Access Compliance Report Public Rights-of-Way (Curb Ramps)

Main Street: VIVIDO_ST		Cross Street: FUTURO_ST		Location:	S
ADA ID: RPRK211116134736	Ramp Type: Type 4 - Parallel	Initial Pass/Fail: Fail	Overall Compliance: No	Severity Score:	15

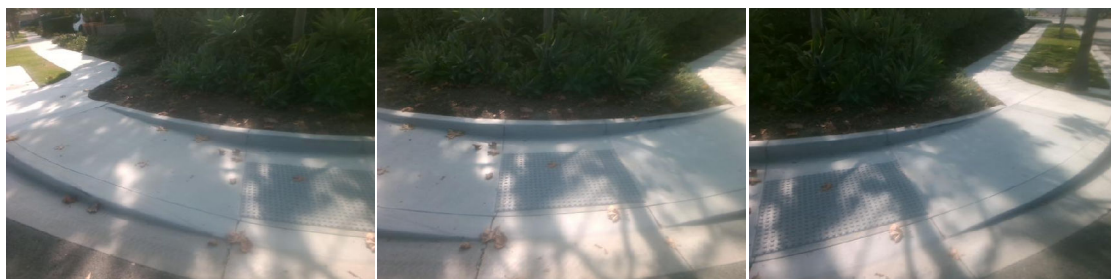
Compliance	Description	Data	Compliance	Description	Data
N/A	Ramp Length LT (in)	117	N/A	Ramp Length RT (in)	110
Yes	Ramp Width LT (in)	53	Yes	Ramp Width RT (in)	53
No	Ramp Run Slope LT (%)	11.6	Yes	Ramp Run Slope RT (%)	1.3
Yes	Ramp Cross Slope LT (%)	0.4	Yes	Ramp Cross Slope RT (%)	1.9
N/A	Landing Present	N/A	N/A	DWS Provided	N/A
N/A	Landing Length (in)	N/A	N/A	DWS Contrast	N/A
N/A	Landing Width (in)	N/A	N/A	DWS Length (in)	N/A
N/A	Landing Run Slope (%)	N/A	N/A	DWS Full Width	N/A
N/A	Landing Cross Slope (%)	N/A		DWS Offset Type	N/A
N/A	Landing Movement Obstructed?	N/A	N/A	DWS Offset Left (in)	N/A
	Landing Movement Type	N/A	N/A	DWS Offset Right (in)	N/A
N/A	Landing Shared	N/A			
N/A	Clear Space	Yes			
N/A	Clear Space To Crosswalk (in)	N/A			
N/A	Marked Crosswalk 1	No	N/A	Marked Crosswalk 2	No
	Crossing 1 Direction	NE		Crossing 2 Direction	NW
	Marked Crosswalk 1 Width (in)	N/A		Marked Crosswalk 2 Width (in)	N/A

Remove & Replace Curb Ramp With Two New Directional Ramps or Equivalent.

R304.3.2, STD 1115
